CSB-1055-2
 Country : UK
 Date : 11/13/2006
 APC : ALL
 Repair Level : 2

Title V3V3_05 CR - GSM - Dust Under Main Lens -Double Sided Adhesive
 Model Effected V3 & V3_05

Cross-Section Dimensions

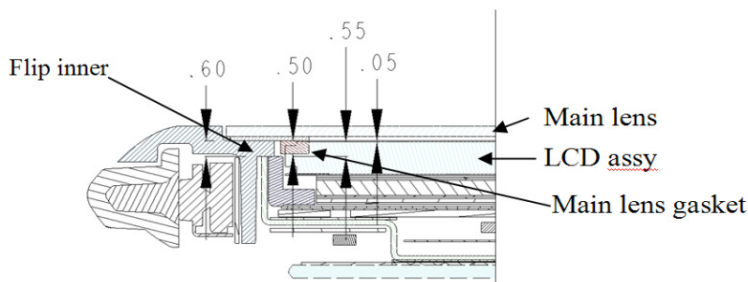
The root cause was glass position within LCD module being lower (away from dust seal) in Sharp displays (7290086N02) due to its stack-up being lower than specification causing less gasket compression which allowed dust to penetrate the seal.

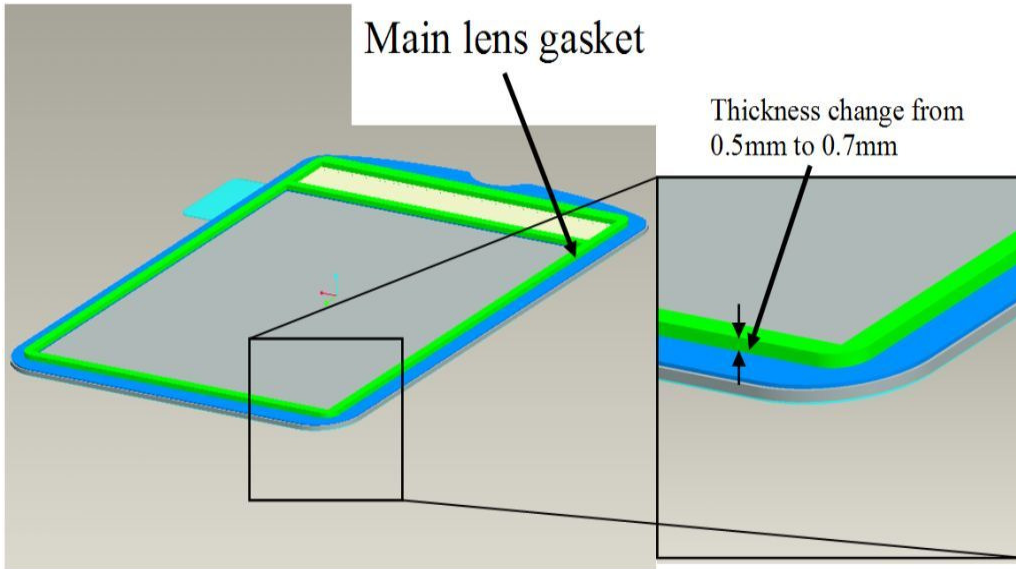
The initial solution for Sharp display was to increase the main lens gasket thickness from 0.5mm to 0.7mm.

The part number for the gasket was changed to 3287306Y05, which is part of the main lens assembly part number 6190016N06 only to be applied on Sharp Displays.

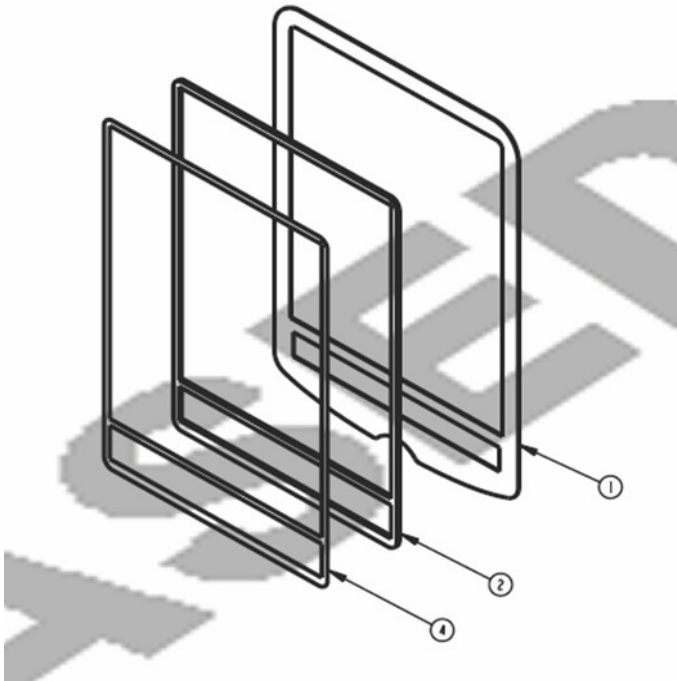
The final solution for all display suppliers including Sharp is to make the main lens gasket with double sided adhesive at 0.5mm thickness to improve the seal. The new part number for all displays is 6190016N11.

After servicing any V3 customer phones with described issue remove the main lens and replace it with (1 = 6190016N11).

Note: Clean any foreign material from the surface of the LCD module using ionized air prior to placing the new lens.

7290086N02
Note the label on display driver
Supplier: Sharp

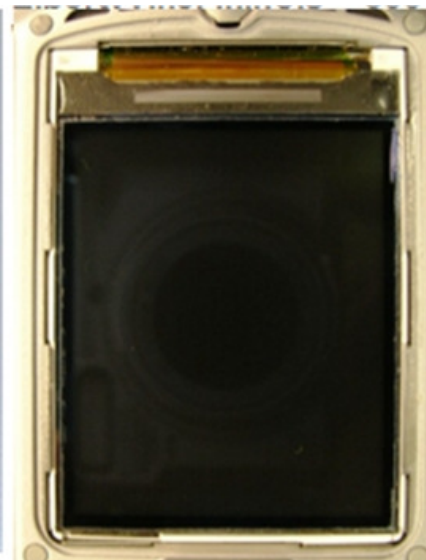
Display Identifiers:
When removing the main lens, Sharp is the only vendor with a label on the display driver IC.
